SUBJECT: Southern California Edison Company's Response to Notice of Violation
- SCE_CAC15_20231219_0851

Finding: Failure to achieve required clearance

Notice	Finding #	Structures
SCE_CAC15_20231219_0851	1	1248323E

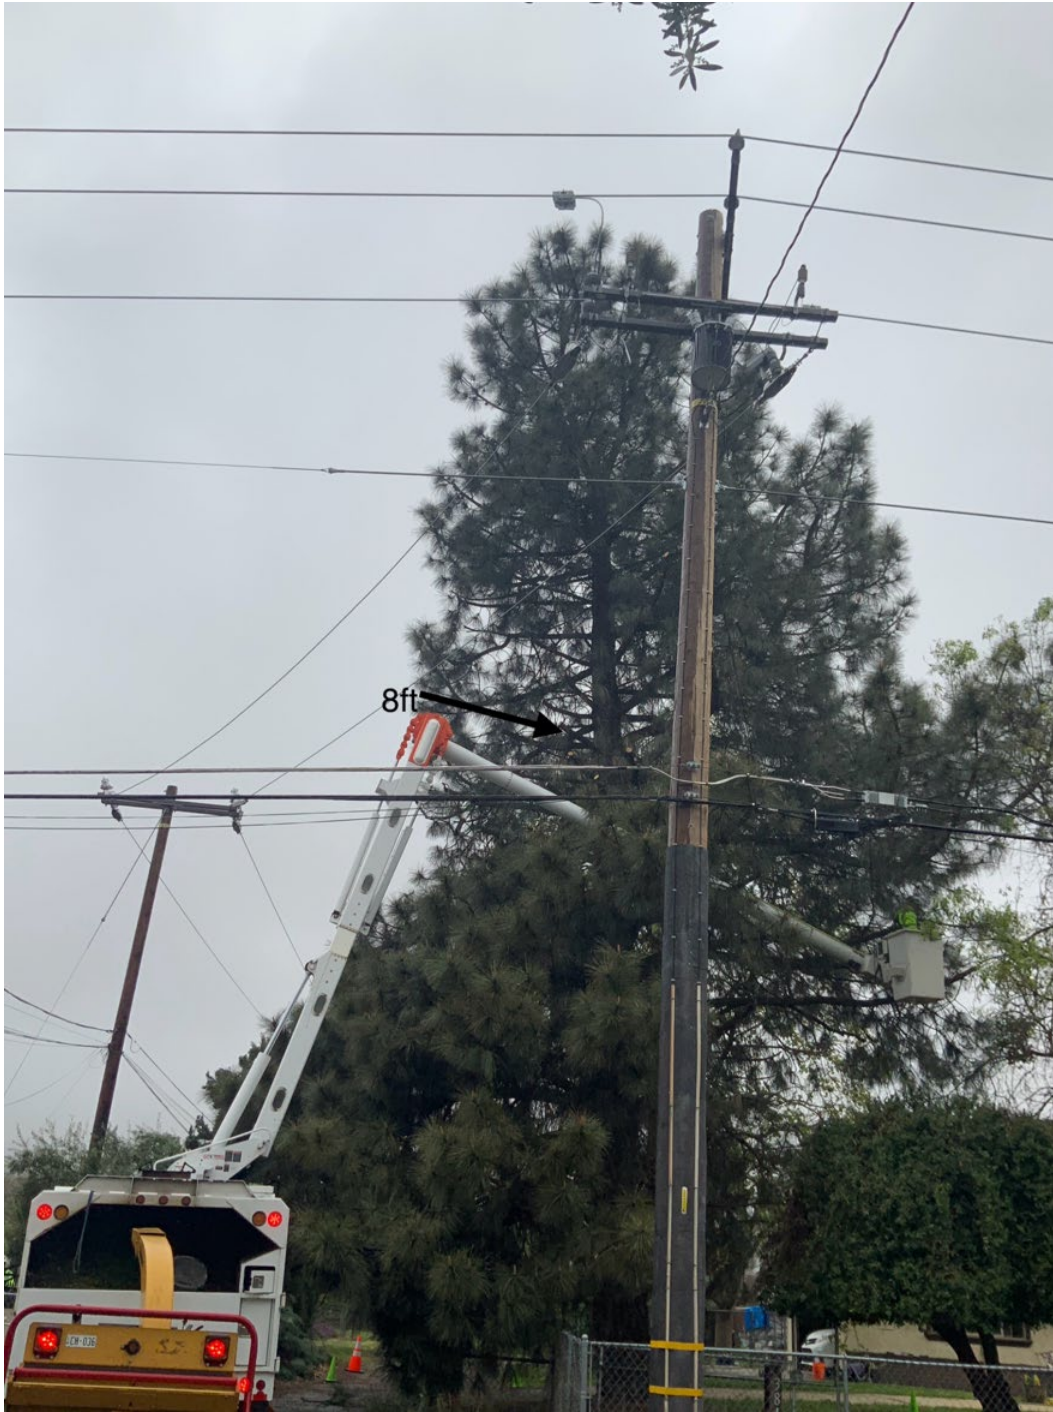
Summary of Finding: “Energy Safety observed that in implementing 2023 WMP initiative number 8.2.3.3.1 – Expanded Clearance, Southern California Edison Company failed to adhere to a required protocol for vegetation clearance near primary conductors, near pole ID 1248323E at coordinates 33.9724233305095, -116.992083439283. Energy Safety considers this violation for failure to adhere to protocol to be in the Minor risk category.

On 4/22/24, SCE dispatched a Vegetation Management Senior Specialist (SSP) who is an ISA Certified Arborist to review the status of the tree. The SSP confirmed the tree had approximately 3 feet of clearance. The tree was last trimmed by SCE on 6/2/2023 and clearance achieved was RCD (minimum 4 feet) plus expected tree growth to maintain clearance for up to 12 additional months. It should also be noted that this is a sensitive customer who typically only allows minimal prunes to be performed on his property.

On 4/24/24, the SCE SSP met with the homeowner and received approval to trim the tree to an enhanced clearance of 8 feet beyond the conductors. Customer would not allow additional clearance. The minimum clearance required per regulation is 4 feet.

On 4/26/24, trimming was performed and achieved a clearance of 8 feet to the conductors. Please see photographs of tree trimming crews performing trimming on 4/26/24.
